New Orleans St. Bern. G 1 to G 105
LAKE PONTCHARTRAIN, LA. AND VICINITY
CHALMETTE AREA PLAN

DESIGN MEMORANDUM No. 3
GENERAL DESIGN

SUBJECT: Lake Pontchartrain, La. and Vicinity, General Design Memorandum
No. 3, Chalmette Area Plan

1. Subject design memorandum is forwarded for review and approval pursuant to para 17, ER 1110-2-1150. Approval is recommended, subject to the comments below and to minor annotations in red on pages 9, 17, 21, 22, and 27.

1 Incl (dupe)
3. Sketch

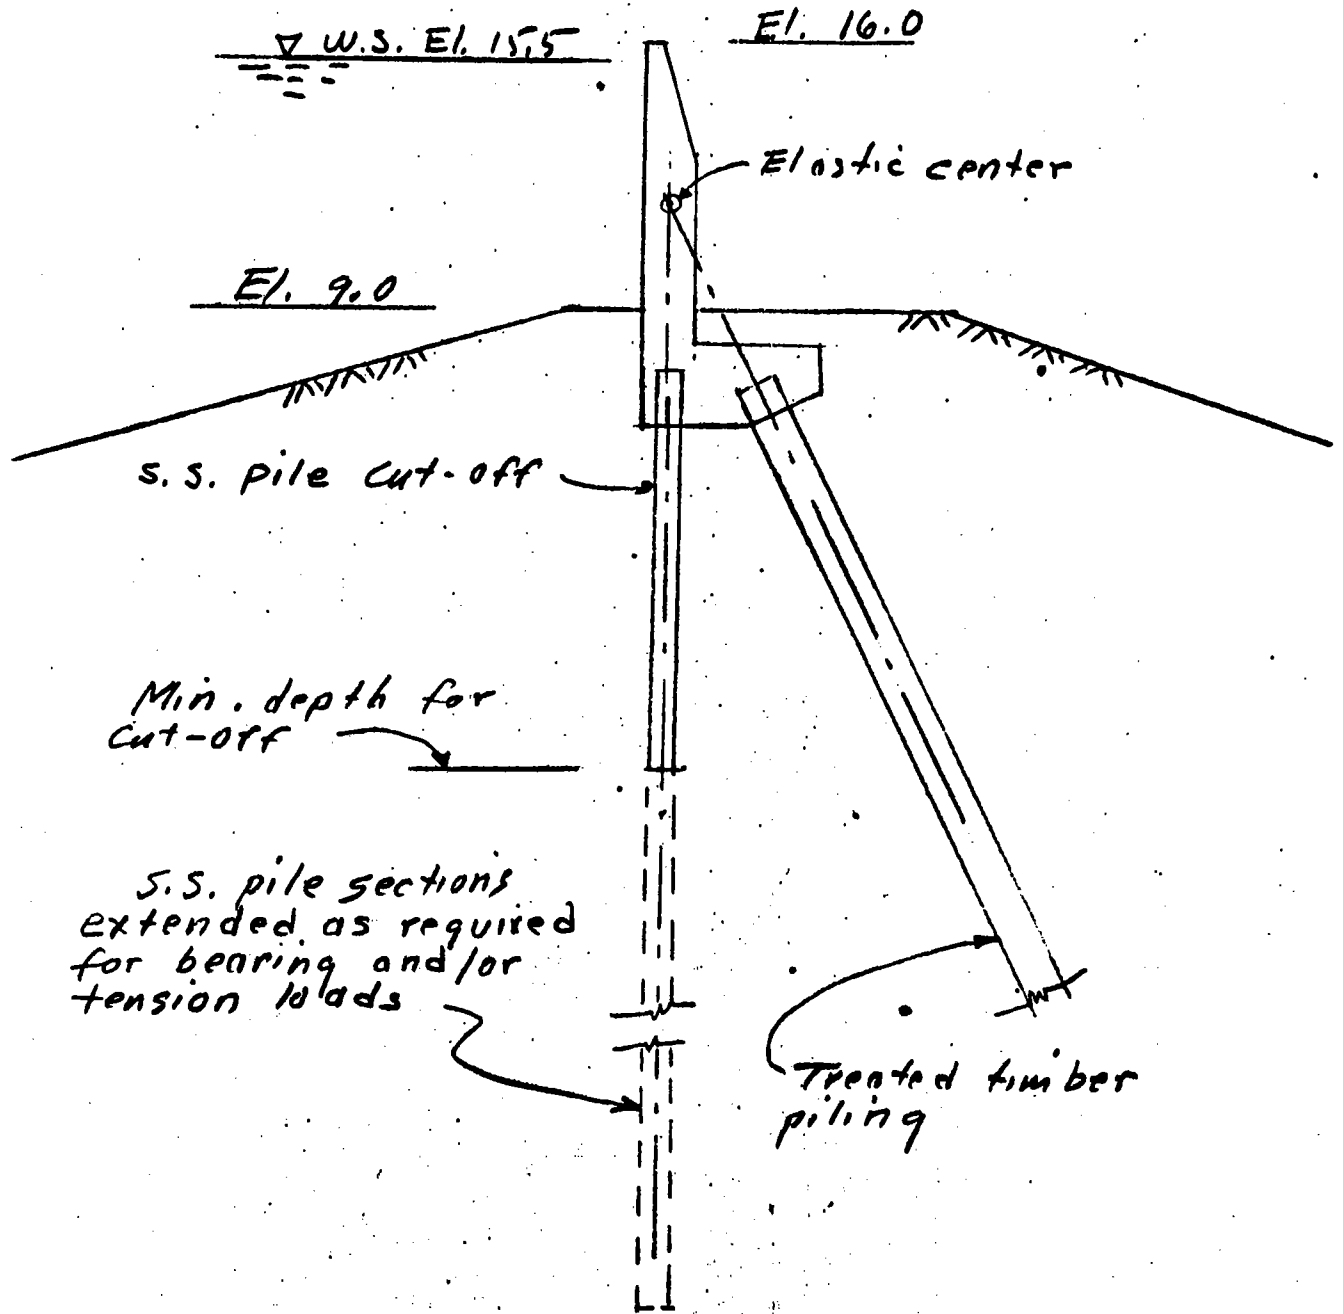
11. Plate 22. Consideration should be given to a wall section using a pile arrangement as shown on Incl 2. This type section will provide a greater vertical component of the wall load and reduce or eliminate tension in the piles battered upstream. The pile loads would be determined by the Culmann method.
